## National Committee on Uniform Traffic Control Devices

### ATTACHMENT NO. 3

**TECHNICAL COMMITTEE:** Markings  
**TOPIC:** Crosswalk Markings  
**STATUS:** Approved by NCUTCD, June 2011  
**ORIGIN OF REQUEST:** FHWA high visibility crosswalk marking study  
**AFFECTED PORTIONS OF MUTCD:** Section 3B.18

Figure 3B-19. Examples of Crosswalk Markings  
[New Figure 3B-19 to replace existing figure]

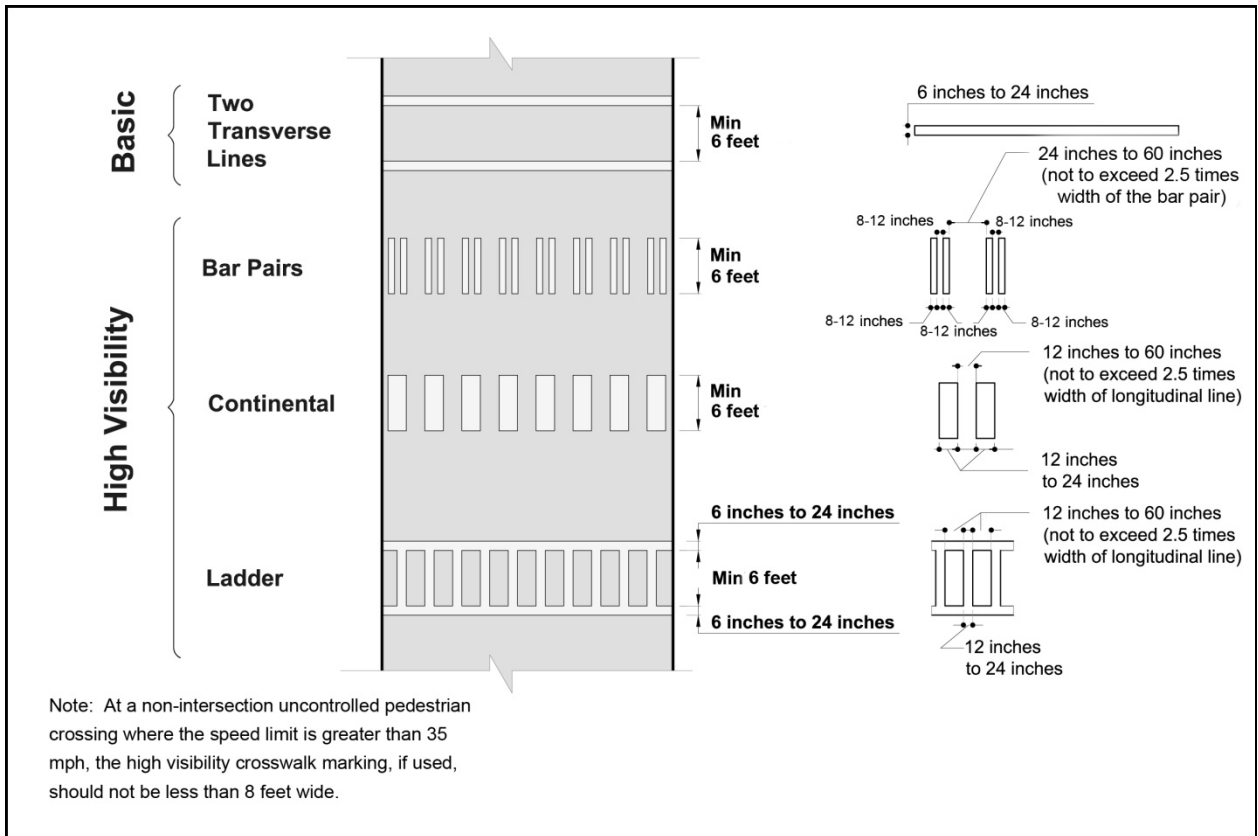
N Crosswalk markings are classified as basic or high visibility. Basic crosswalk markings consist of two transverse lines. High visibility markings consist of longitudinal lines parallel to traffic flow with or without transverse lines. Figure 3B-19 presents examples of crosswalk markings. [note: Figure 3B-19 has been revised]

[Existing Figure 3B-19 replaced with new Figure 3B-19 on next page]
